► Kramer, O.J.I., de Moel, P.J., Raaghav, S.K.R., Baars, E.T., van Vugt, W.H., Breugem, W.-P., Padding, J.T., and van der Hoek, J.P., Can terminal settling velocity and drag of natural particles in water ever be predicted accurately?, *Drinking Water Engineering Science Journal*, Discussion, <https://doi.org/10.5194/dwes-2020-30>, under review, 2020

This paper is a very detailed discussion of the spread of 3,629 terminal settling experiments and of related literature data. Scientific sustained arguments leads to the conclusion that new advanced research is needed to improve the prediction accuracy for settling velocity, drag coefficient and terminal Reynolds number of non-spherical particles such as drinking water related particles. The quality of the paper has to be upgraded by the following minor revisions:

This paper pulls together old data and models and combines them with new data and new analyses related to predicting the terminal settling velocity of particles in a water treatment setting. I think the paper is valuable, accurate, and should be published. I thought the paper could have been a little more streamlined and straight-forward as there was an element of trying to

**Figure 9** State diagram. Galileo number  $Ga$  versus specific gravity number  $\bar{\rho}$  with examined particles

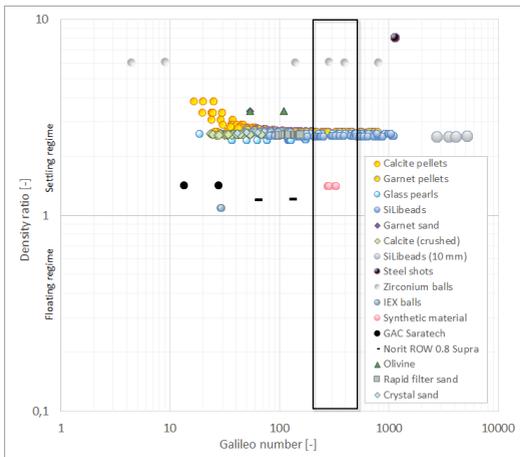
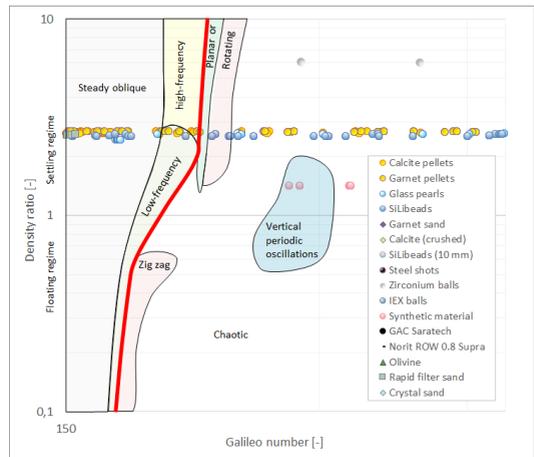
- Figures 9+10: It is not clear why half of each graph shows density ratios less than 1. It seems these particles would float (instead of settle) and no particles appear to fit into this range. In Fig 10, the "zig zag" region only occurs where there are no particles, and the boundaries of the "chaotic" region are unclear. Is it everywhere that is white or only below a density ratio of 1. Needs revision.

Adjusted. This state diagram is based on literature which addresses path instabilities (Jenny et al., 2004); (Veldhuis and Biesheuvel, 2007); (Zhou and Dušek, 2015). They studied, besides, settling particles also floating particle, where the density ratios are less than 1. In addition, this also carried out by Raaghav, 2019) who is co-author of this research.

This regime map is a bit complex. Therefore figures 9 and 10 are updated. A red line indicated the boundary between steady oblique and chaotic regime. In addition floating and settling regime is indicated.
